RS21 Cup Cala de' Medici

Notice to Competitors

Mainsheet system

Source: Technical Committee

[Schermata 2021-07-01 alle 17.48.31.png 102 KB](#)

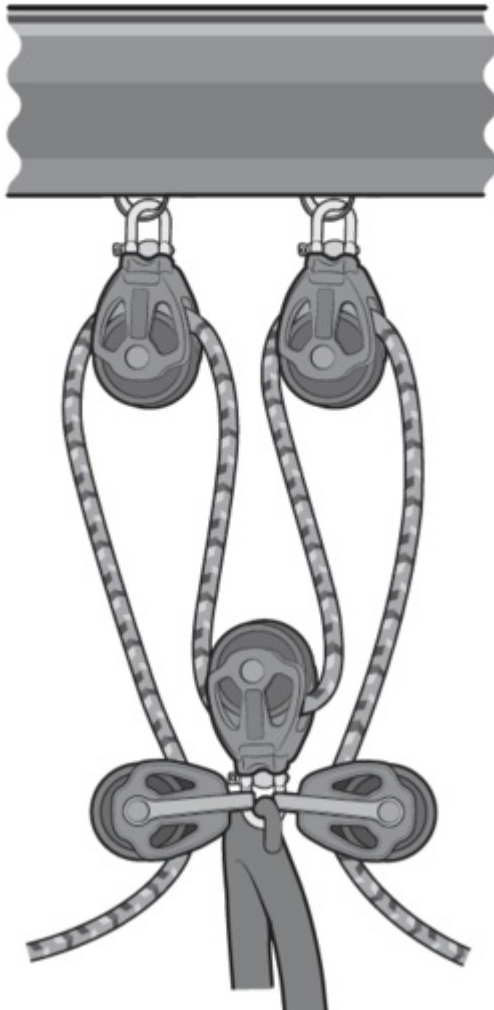
the mainsheet must be thread as for "RS21 rigging guide" available on the RS21 website <https://www.rssailing.com/wp-content/uploads/guides/RS21Riggingguide.pdf>

Pass the tails through the ratchet blocks as shown.
